Service Bulletin

Bulletin No.: 17-NA-097

Subject: Side Blind Zone is Not Working Correctly and/or Incorrect Side Mirror Notification

Brand:	Model:	Model Year:		VIN:		Engine:	Transmission:
		from	to	from	to		
Chevrolet	Bolt EV	2017	2017				
Opel / Vauxhall	Ampera-e	2017	2017

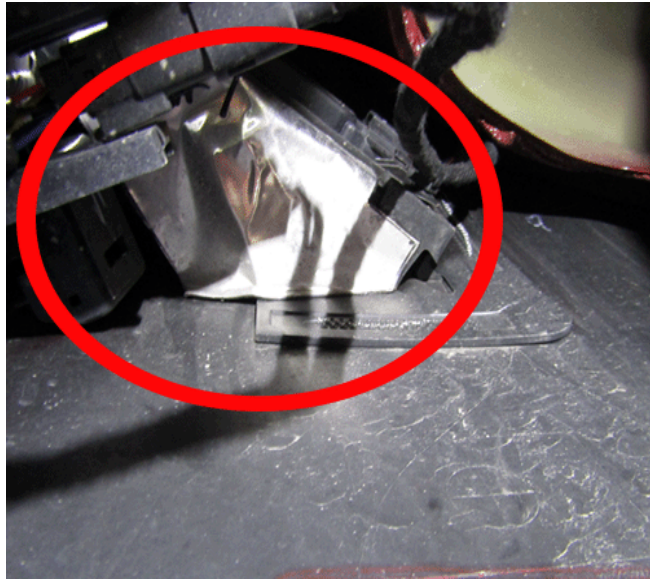
Involved Region or Country	North America, Europe, South Korea
Additional Options (RPOs)	Equipped with Side Active Safety Obstacle Detection Enhanced (RPO UKC)
Condition	<p>Some customers may comment when driving, the side mirror indicates there is a vehicle present when there actually is not.</p> <p>The technician may find one or more of the following conditions:</p> <ul style="list-style-type: none">• Wiring harness to the sensors may not be properly connected or routed.• Butyl tape not covering the sensor bracket completely.• Butyl tape missing completely.
Cause	<p>If the side blind zone has been found not working properly, inspect one or more of the following areas:</p> <ul style="list-style-type: none">• Butyl tape application at the sensor brackets.• Sensor harness electrical connection and routing.• Poor grounding at the G401 and/or G404 body ground.
Correction 1	<div></div> <p>4749843</p> <p>Inspect the wiring harness electrical connectors for proper connections and routing.</p>

4749759

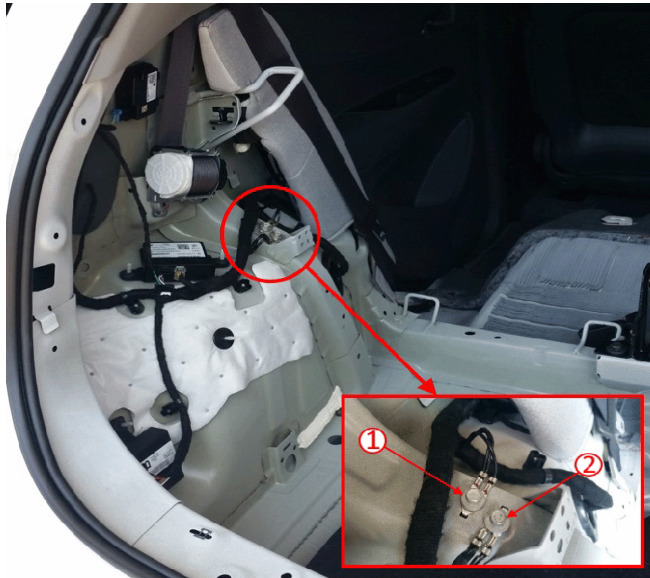
Correction 2

Important: The opening must be completely covered with the butyl tape to avoid allowing unwanted radar reflection to be detected and triggering the false alerts. Install a new single piece of aluminum butyl tape on the bottom of the object sensing alert module brackets so the opening is completely covered by the tape.

4847139

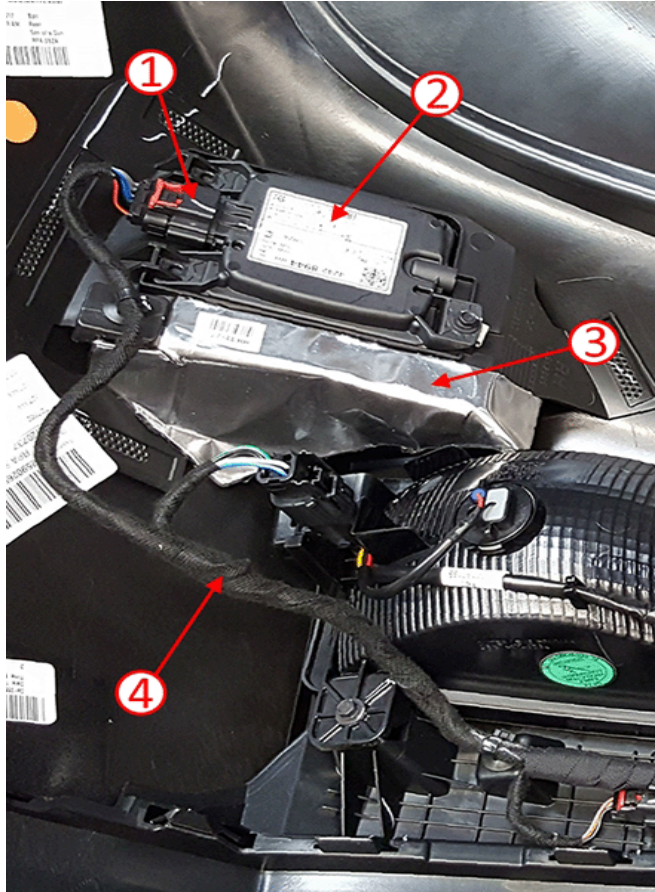
Correction 3

Remove the G401 (2) and G404 (1) grounds. Clean and remove paint from contact points.
